DRWN	Hazel 12-29-95	DATE	12/29/95
CHK		SCALE	1/2
LIGO PROJECT		SMALL OPTIC SUSPENSION ASSEMBLY	
CALIFORNIA INSTITUTE OF TECHNOLOGY			
MASONNETT'S INSTITUTE OF TECHNOLOGY			
/www.msi.edu/usa/0960001.pdf			
PROJECT	0960001	DATE	0960001-C-D
SCALE	1/2	DATE	0960001-C-D

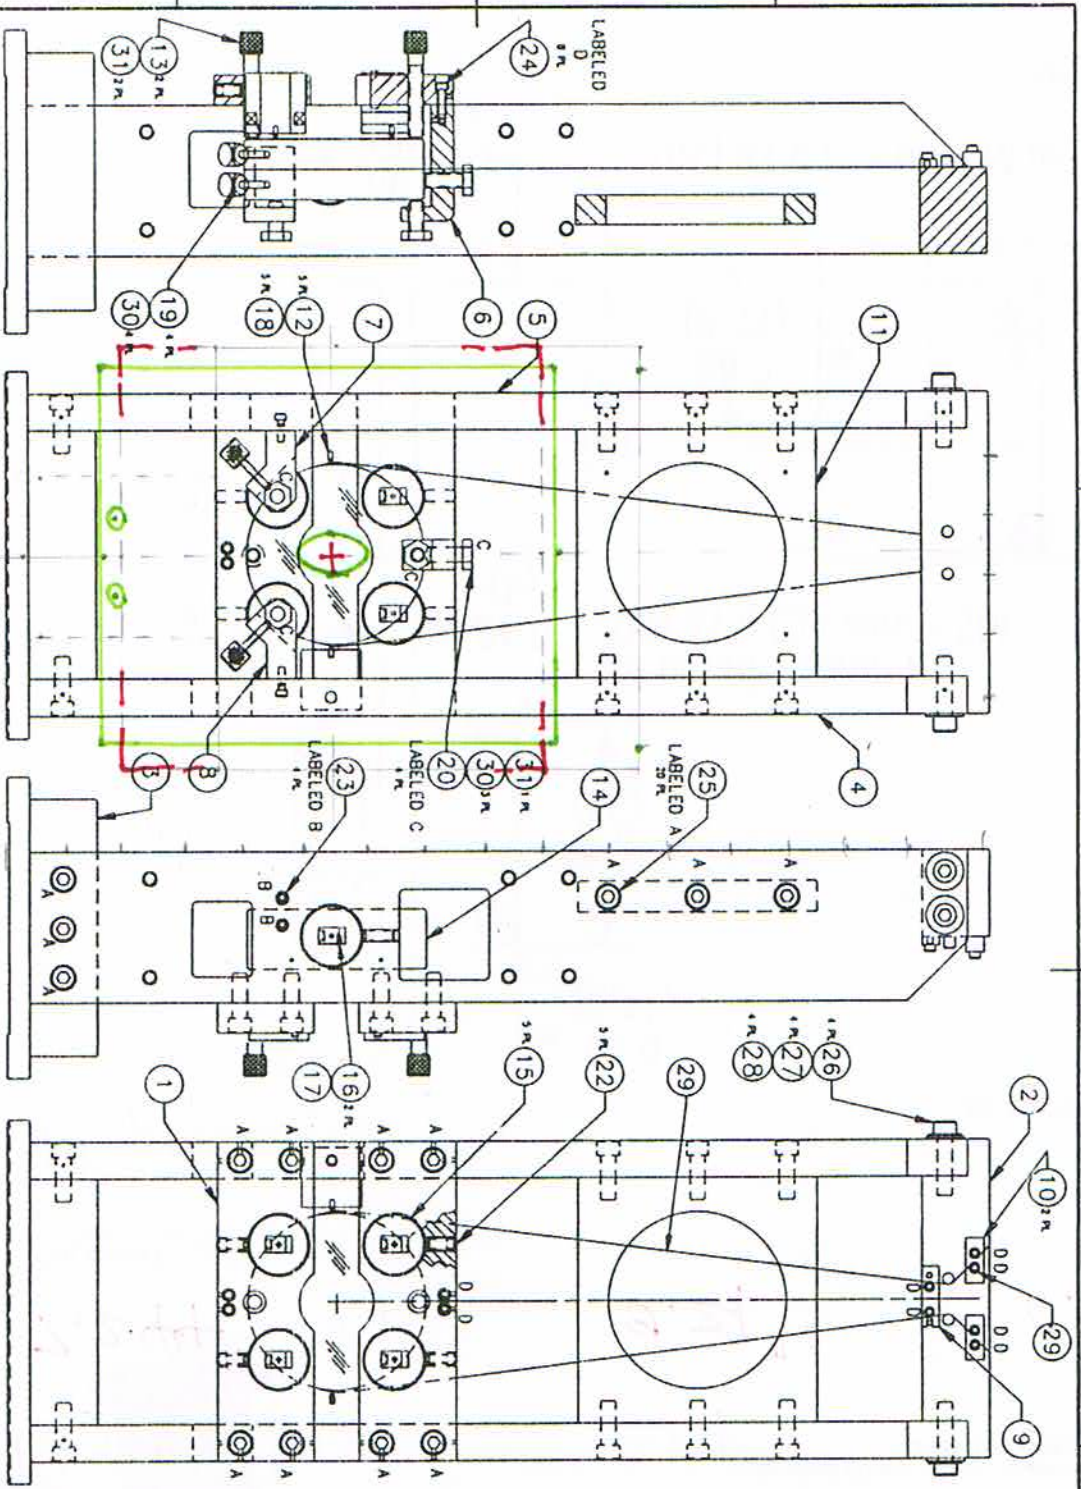
Add lock washers to OSEM PLATE
